Serial No.: 10/807,002

## **AMENDMENTS IN THE DRAWINGS:**

### **REMARKS**

FIG11

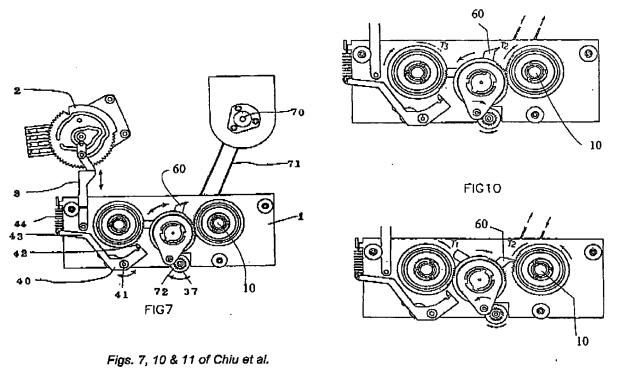
Referring to Figs. 7, 10 and 11 reproduced above, Chiu et al. describes a capstan motor 70 which drives a belt 71, which in turn drives a transmission gear 37. (See, e.g., Fig. 7; column 2, lines 53-58). The transmission gear 37 in turn drives a drive gear 36. When the capstan motor 70 runs clockwise as represented in Fig. 11, the clutch tooth 60 engages with the gear 13 (labeled in Fig. 2) of the take-up reel 10 so as to prevent rotation of the take-up reel 10. (See, e.g., column 4, lines 26-34).

When the capstan motor 70 rotates counter-clockwise as shown in Fig. 10, the clutch tooth 60 disengages the gear 13 of the take-up reel 10 so as to release the take-up reel 10.

In Chiu et al., it is <u>not</u> the rotation of the reel stand 10 in a first direction which is conveyed to some type of contact portion so as to cause the clutch tooth 60 to engage the gear 13 of the reel 10 (as shown in Fig. 11). Rather, it is the rotation of the capstan motor 70 which in turn drives the gears 36, 37 and swing arm 31 so as to cause the clutch tooth 60 to engage the reel 10. In other words, it is <u>not</u> the rotation of the reel 10 in Chiu et al. that is being conveyed to the clutch tooth 60 in order to cause contact with the reel 10. In this respect, Chiu et al. is similar to the conventional art of Figs. 5 and 6 in the present application.
